Subject: Three Mile Island Nuclear Station, Unit 1 (TMI-1)
Operating License No. DPR 50
Docket No. 50-289
GPU Nuclear Response to NRC Request for Additional
Information Regarding the TMI-1 20th Year Reactor Building
Tendon Surveillance Test

**GPU NUCLEAR CORPORATION
THREE MILE ISLAND UNIT 1
TENDON SURVEILLANCE PROGRAM
RESOLUTION OF NRC QUESTIONS**

FIGURE 3.1

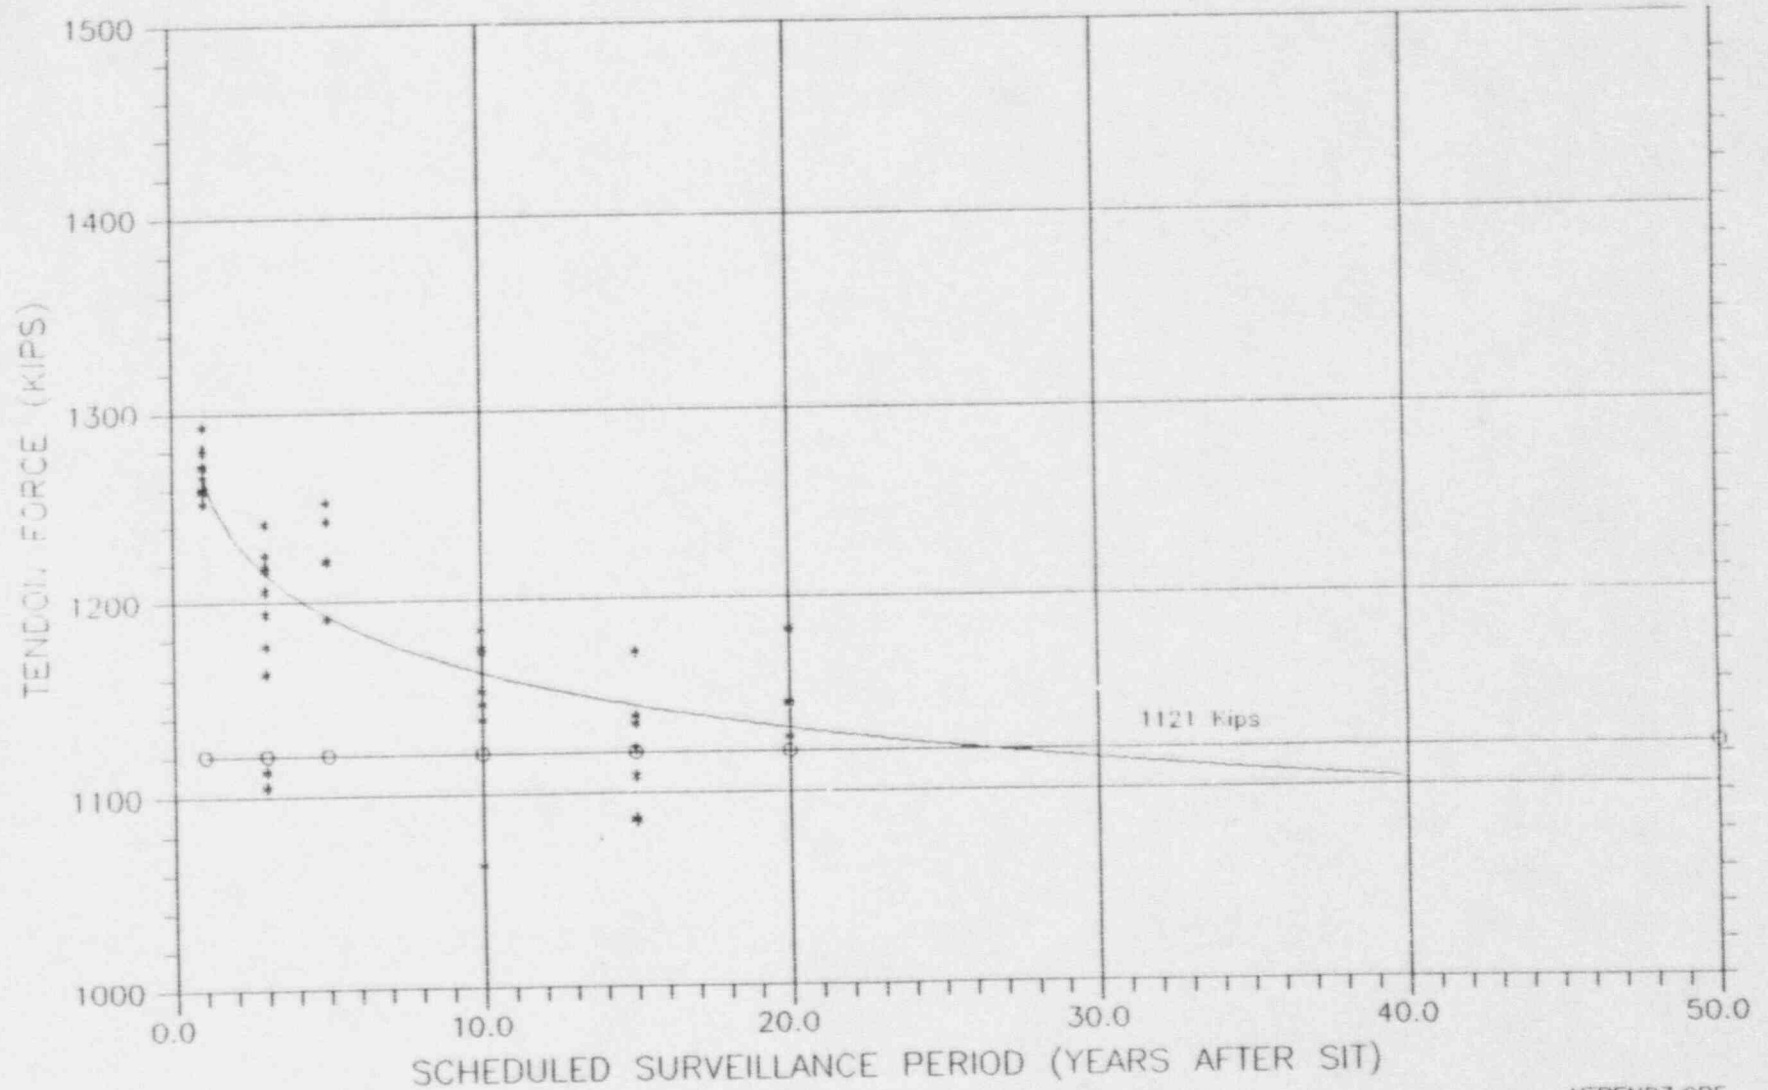
For the Attachment B and other similar Figures within the Topical Report, explain how the lift-off force is represented by one value. Explain how this representative force is established and how the trend line was obtained. All the tendon lift-off forces for all surveillances should be used without any normalization and linear regression analysis should be performed to obtain the trend.

With respect to the linear regression, GPU Nuclear reviewed the tendon lift-off data points from all prior surveillances and concluded that the prestress loss was indeed larger in the early life of the plant, and that these losses now have leveled off significantly. A pure linear regression of the data points is therefore not appropriate and is not used. The curve selected is a best fit among all the data points considering a steeper slope in the initial years, and leveling out as losses are shown to have stabilized. The curve for the hoop tendons was prepared using engineering judgment as a best fit for the data points and is shown as Attachment B in the Topical Report.

Utilizing the data from Topical Report Attachment B, the hoop tendon curve has been duplicated herein using a mathematical regression best fit curve as shown in the attached Figure 3.1. This curve utilizes all lift-off points without being normalized. The results of this curve show that the regression line may fall below the minimum required prestress force for the hoop group in about 6 years. While this curve differs slightly from the curve contained in the Topical Report, it still shows that the tendon force values are expected to be above the minimum required value at the next surveillance. A similar curve will be generated after the next surveillance period to determine if forces remain at acceptable levels. If the results obtained in the 25th year surveillance indicate that forces would be expected to drop below the minimum required value, GPU Nuclear would take appropriate action.

Figure 5.1
 Tendon D248 : Force-Elongation relationship during retensioning

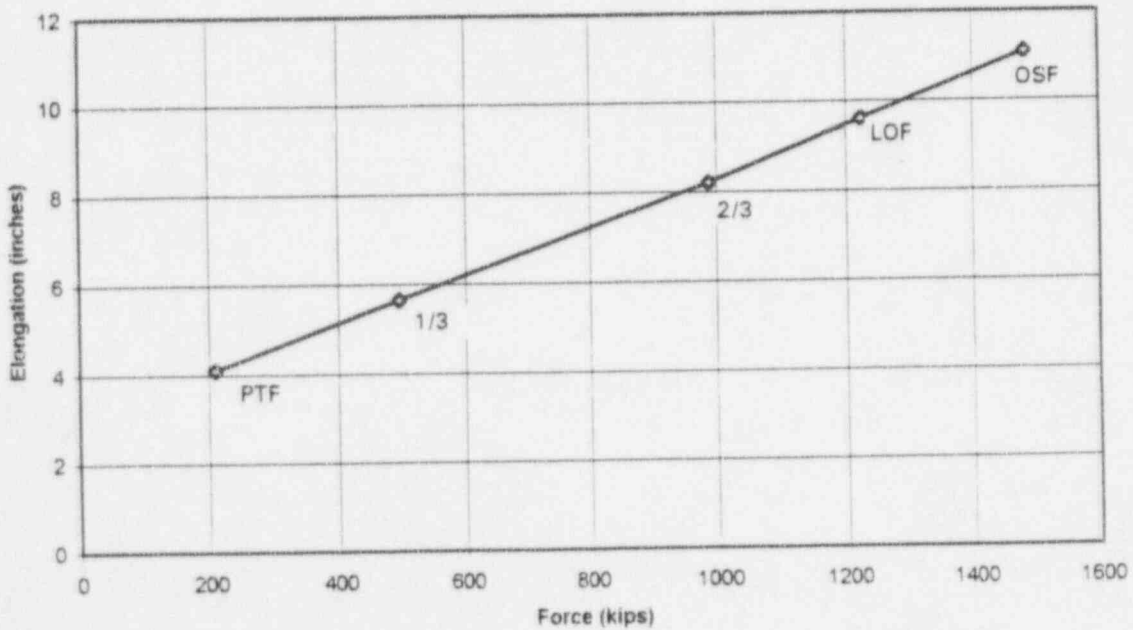
Provide force-elongation information in the requested format for each detensioned and retensioned tendon at the required 1/3 and 2/3 increments as required by Regulatory Guide 1.35. Prepare graphs showing the linear force-elongation relationship for each tendon. Explain and discuss the implications if not linear.

Figures 5.1, 5.2 and 5.3 were also prepared as requested and are attached. These figures represent the plotted force-elongation relationship for the three retensioned tendons.

The resulting force-elongation plots show very good linearity as the tendon is retensioned through the 1/3 and 2/3 increment points and up to the OSF. The graphs of all three tendons show excellent linear correlation between the measured incremental elongation and the force in the tendon during the retensioning process. For Hoop Tendon H35-47, the LOF is somewhat off the linear slope. This condition occurs because the shims have a finite thickness and can compress under load. This results in the LOF being a step function rather than a linear function. The LOF point is also taken after reversing the tensioning direction downward from the OSF, rather than during the retensioning process as all other points are established.
